ORDER NO. 20-200

UM 2056

Oregon Transportation Electrification Plan.

SUBJECT: OREGON PUBLIC UTILITY COMMISSION STAFF:
(Docket No. UM 2056)
Recommendation on acceptance of Pacific Power's Transportation
Electrification Plan.

Projected Number of EVs in Pacific Power's Territory Through 2025

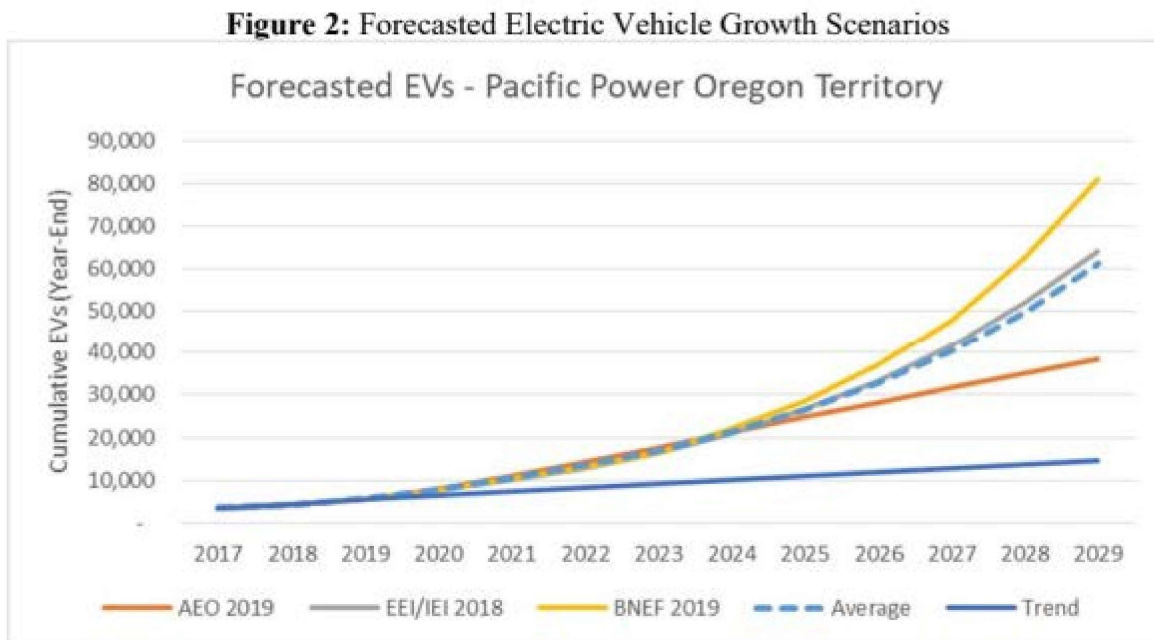
The Plan included the Company's first forecast of EVs in its Oregon service territory.⁹ Staff sought a comparison of the forecast method with historical numbers from 2017 to 2018 in order to determine if the averages of past forecasts overestimated, or underestimated, the Company's known annual EV counts.¹⁰

All forecasts grow at a higher rate than an extrapolated trend of what has been observed in Pacific Power's service territory in recent years. This suggests the Company's forecast may overestimate EV adoption by Pacific Power's customers, a problem that can be further addressed in the next integrated resource plan and distribution system plan.

In Figure 2, the Company replied with a trend analysis utilizing actuals from 2016 to 2019:¹¹
